**Pacific Gas and  
Electric Company®**

PG&E Letter DCL-06-080

Docket No. 50-275, OL-DPR-80  
Diablo Canyon Unit 1  
PG&E Response to NRC Request for Additional Information Regarding,  
"Special Report 06-01 - Results of Steam Generator (SG) Tube Inspections for  
Diablo Canyon Power Plant Unit 1 Thirteenth Refueling Outage"

**PG&E Response to NRC Request for Additional Information (RAI)  
Regarding 1R13 SG Tube Inspections**

Figure 1

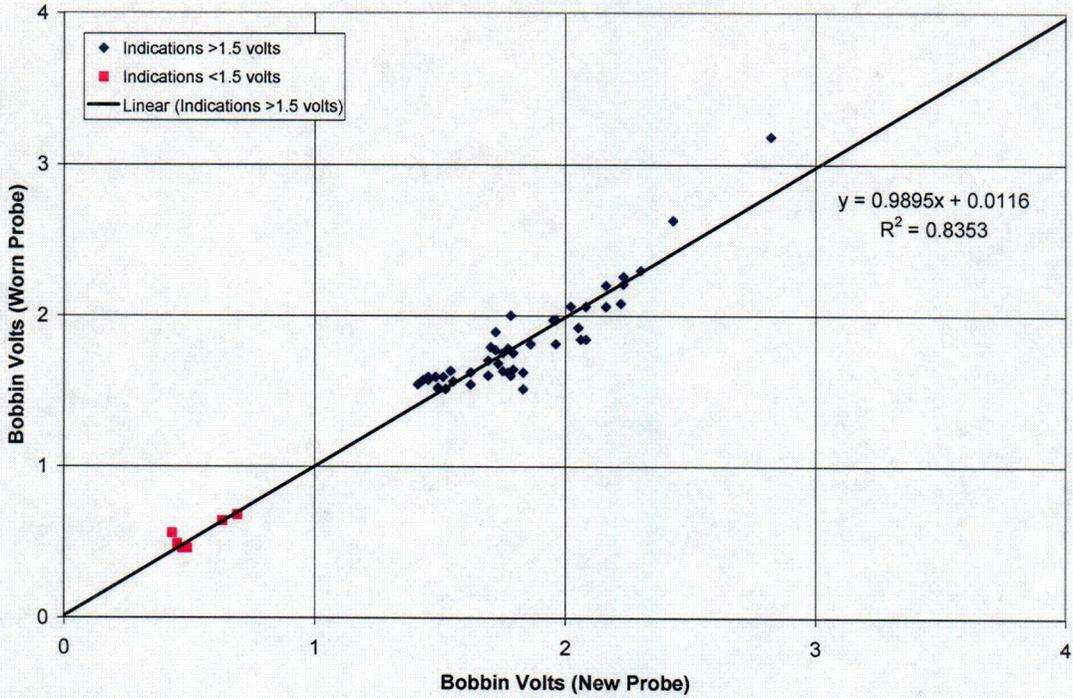
*Table 3-18 of Enclosure 4 to your February 24, 2006 letter, lists indications that were re-inspected following a failed probe wear check. In evaluating the data in Table 3-18, it appears that all indications are greater than 75% of the tube repair criteria (1.5 volts). Please confirm that the tubes re-tested with a "good (non-worn)" probe only had indications greater than 1.5 volts. If there were other indications (i.e., less than 1.5 volts), please update Table 3-18 and Figure 3-37 with this data. This analysis is consistent with the staff's approval of the alternate probe wear criteria.*

The purpose of Table 3-18 was to provide a list of all 1R13 ODSCC indications greater than or equal to 75 percent of the tube repair criteria (1.5 volts) that failed the probe wear check, as these required retesting in 1R13 with a good (non-worn) probe. Indications less than 1.5 volts that were inspected with a worn

probe do not require retesting with a good probe, unless they are in a same tube as a greater than or equal to 1.5 volt indication tested with a worn probe, because retesting with a good probe is performed the entire length of the tubing. Because of this, there were 5 indications less than 1.5 volts that were originally inspected with a worn probe which were retested with a good probe, due to the indications being located in tubes already identified in Table 3-18. Table 2 provides these indications. Figure 1 is an update to Figure 3-37 and includes these 5 indications.
